## Location and Extent Staff Report

**Subject:** Rampart Delivery System Expansion – Location and Extent

**Project File:** LE2026-008

The City of Aurora requests approval of a Location and Extent application (L & E) for the Rampart Delivery System (RDS) Expansion Project. The project includes approximately 6.5 miles of 76-inch diameter steel pipeline and replacement of the existing above grade outlet works valve building. The improvements are necessary to accommodate increased water supply needed in the City and in Douglas County. The project will connect to Aurora's existing RDS system, The Denver Water Foothills Water Treatment Plant, and the Roxborough Water and Sanitation District system.

**ALIGNMENT AND VICINITY MAP**  
STA 329+00 to 358+36

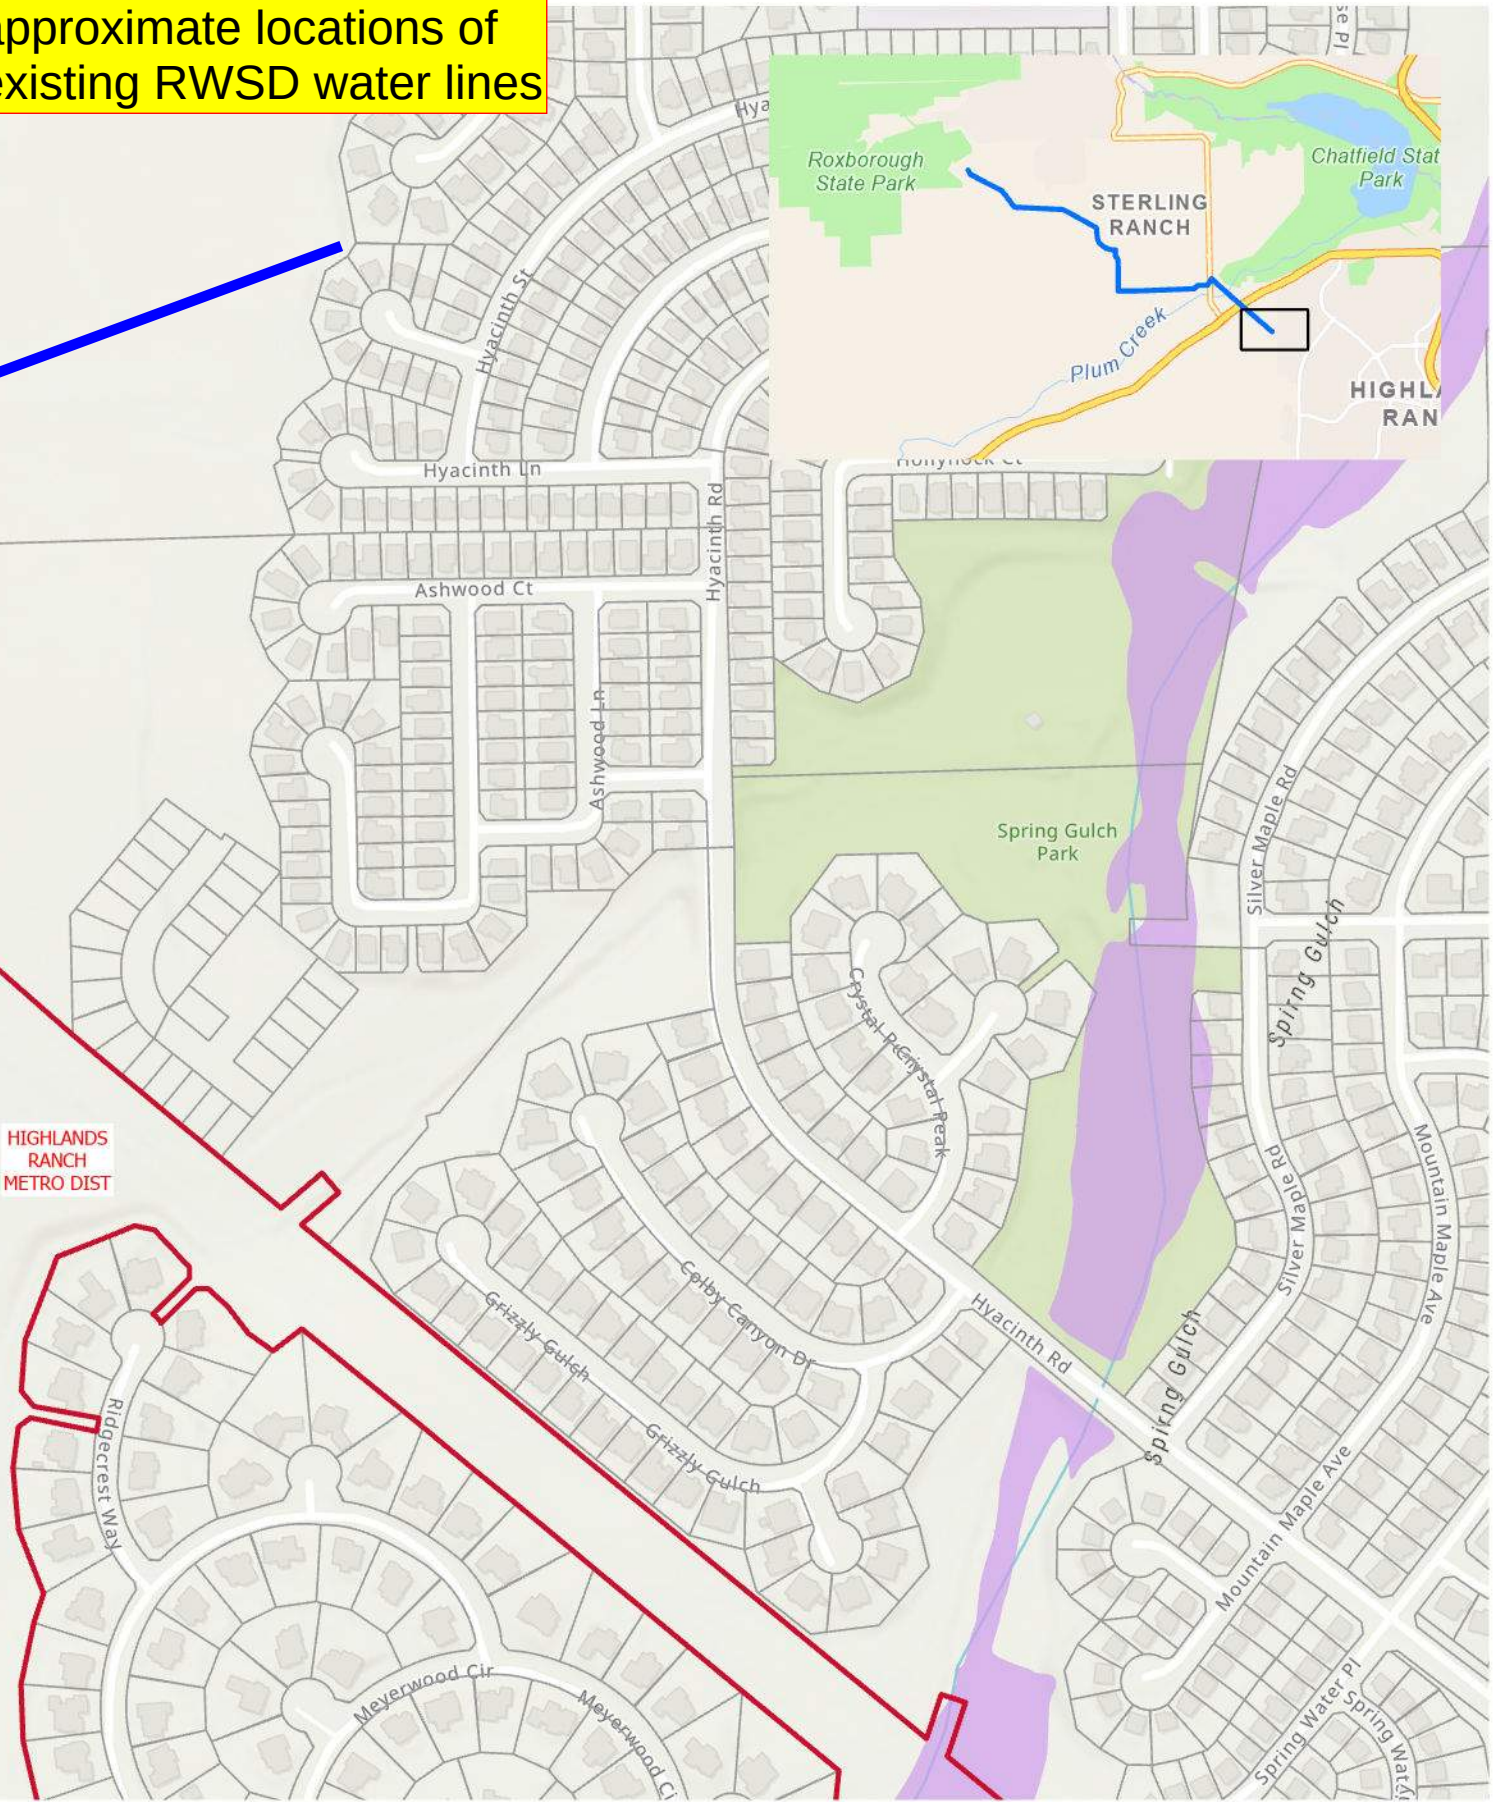
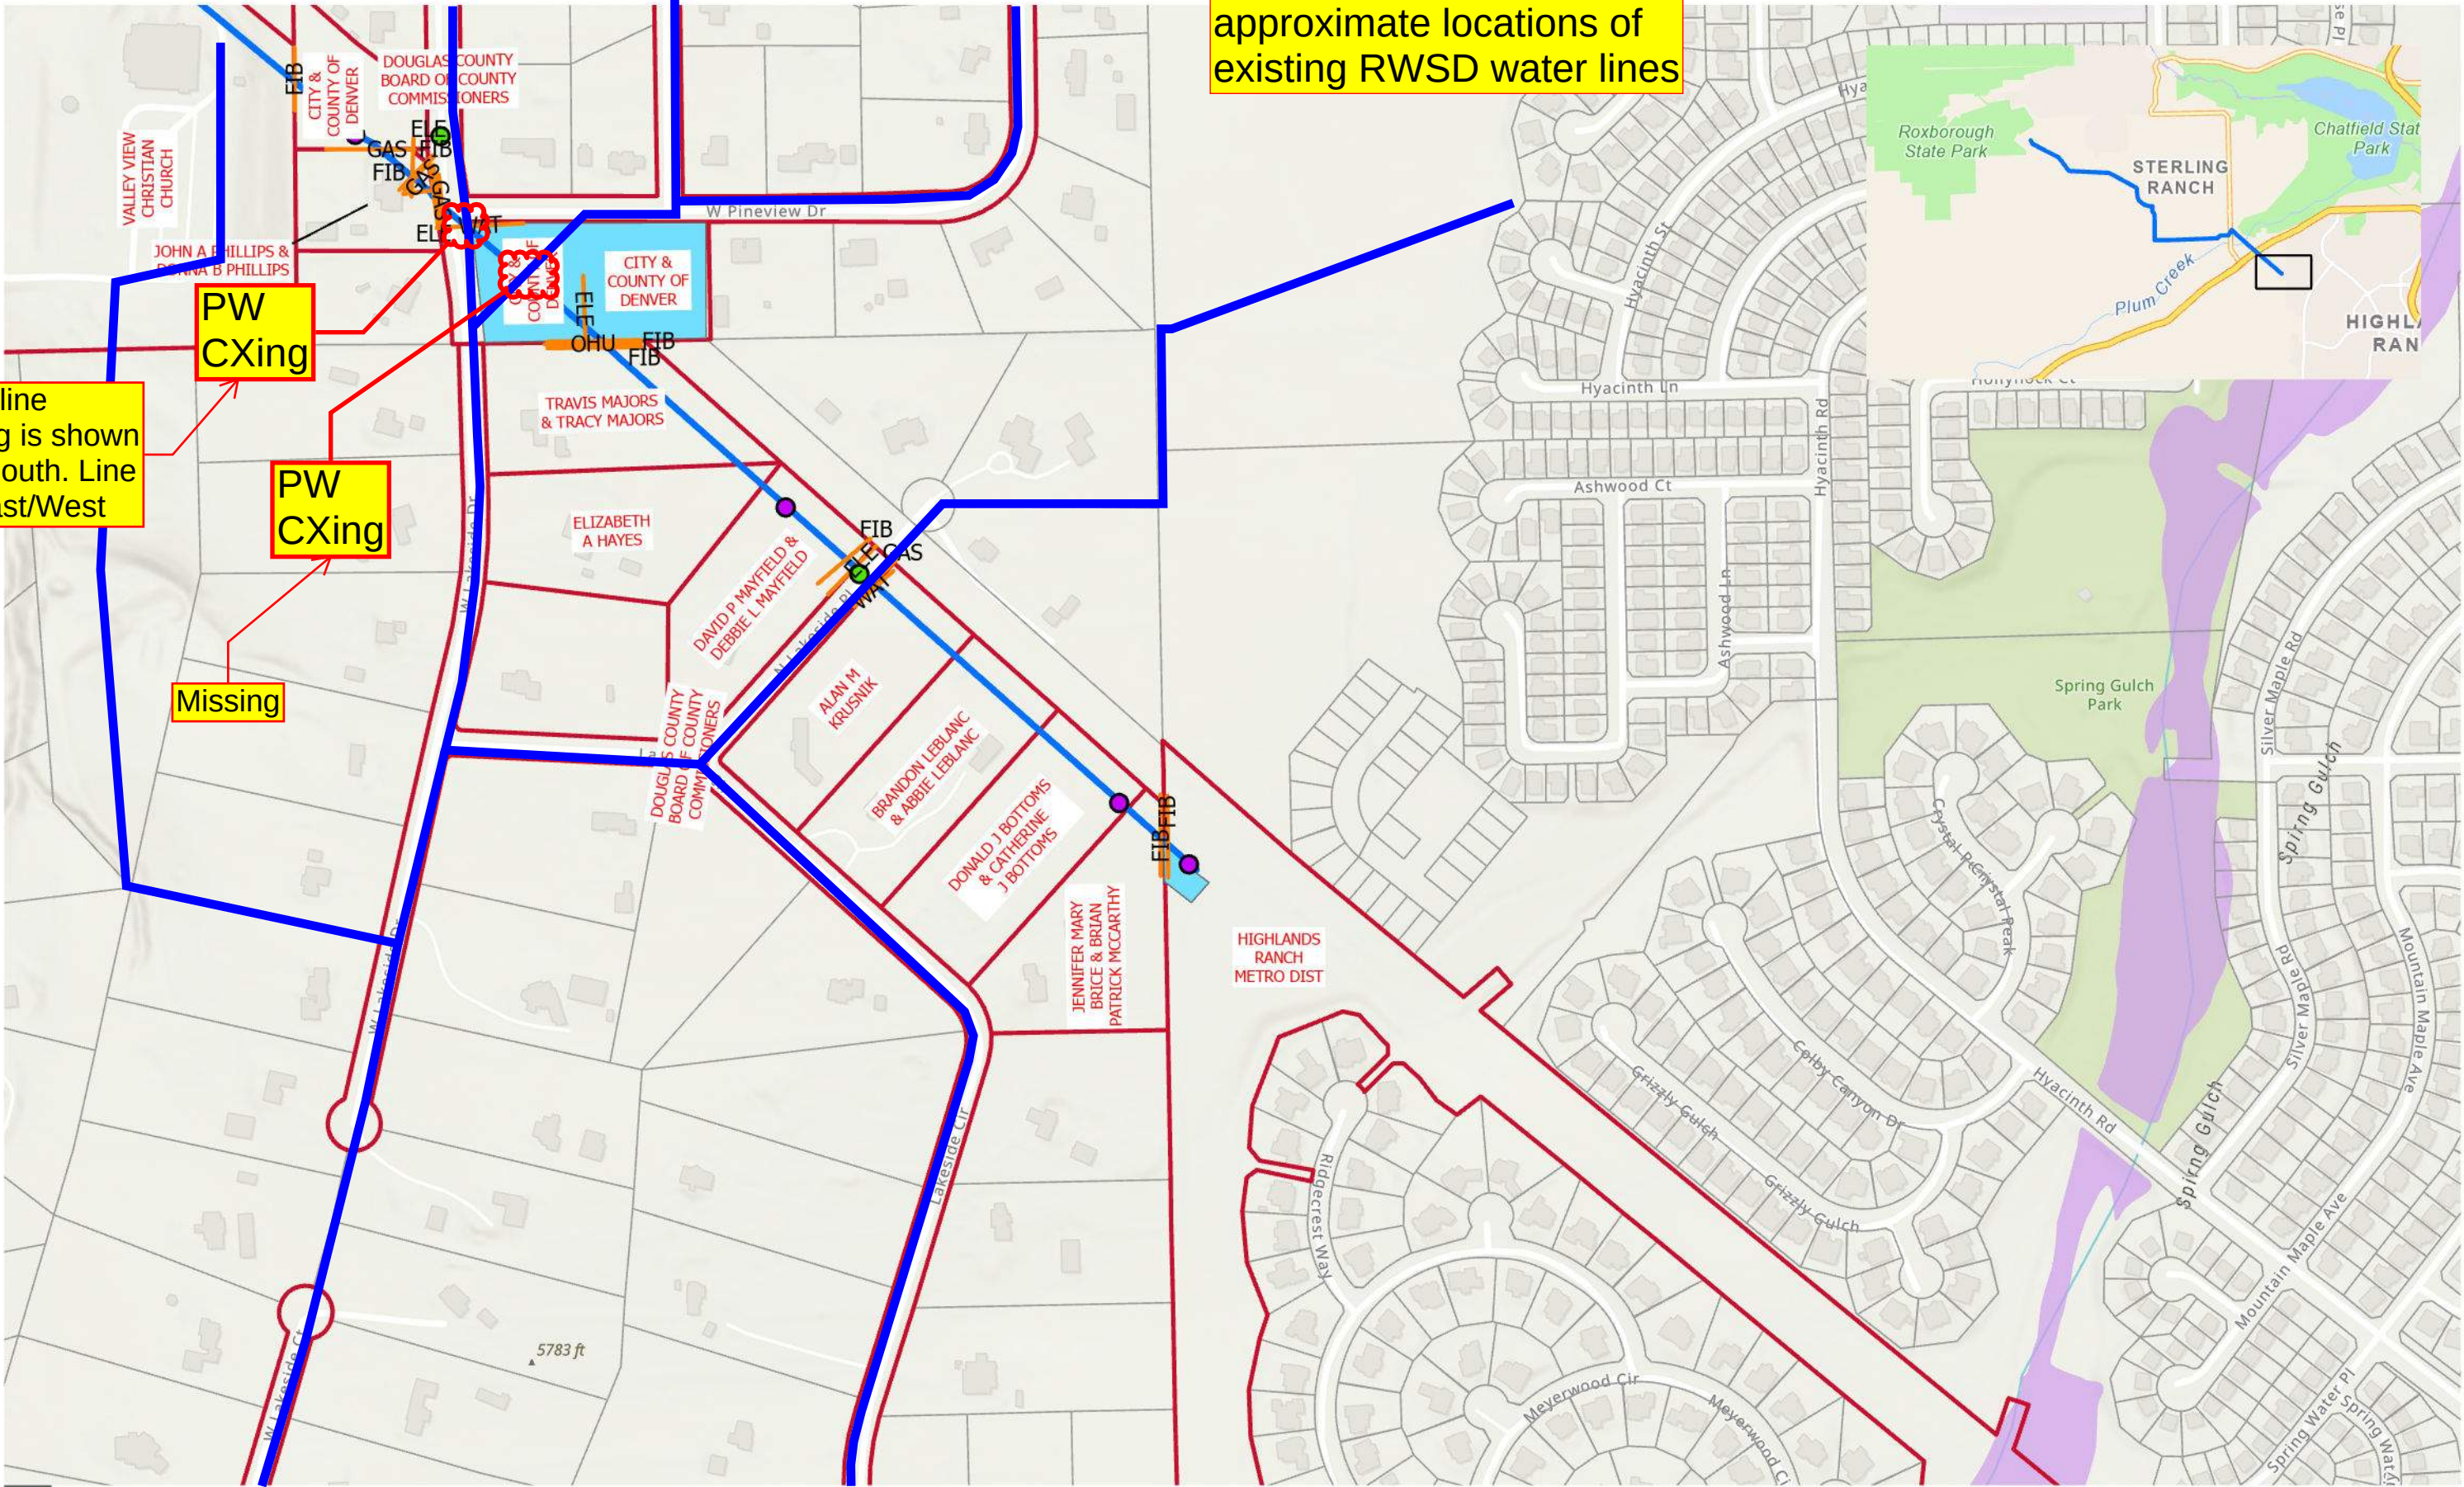
1. On the Alignment and Vicinity Map sheet for STA 329+00 to 358+36, the proposed crossing of RWSD's water main at the intersection of W Pineview Drive and W Lakeside Drive depicts the existing RWSD water main as running north-south. However, the District's records drawings indicate this water main runs east-west along W Lakeside Drive.
2. On the Alignment and Vicinity Map sheet for STA 329+00 to 358+36, RWSD has an existing 8 inch water main that runs northwest to southeast across the parcel owned by the City & County of Denver at the intersection of W Pineview Dr and W Lakeside Drive. The exhibit does not show this proposed water main crossing.

RWSD line crossing is shown North/South. Line runs East/West

Missing
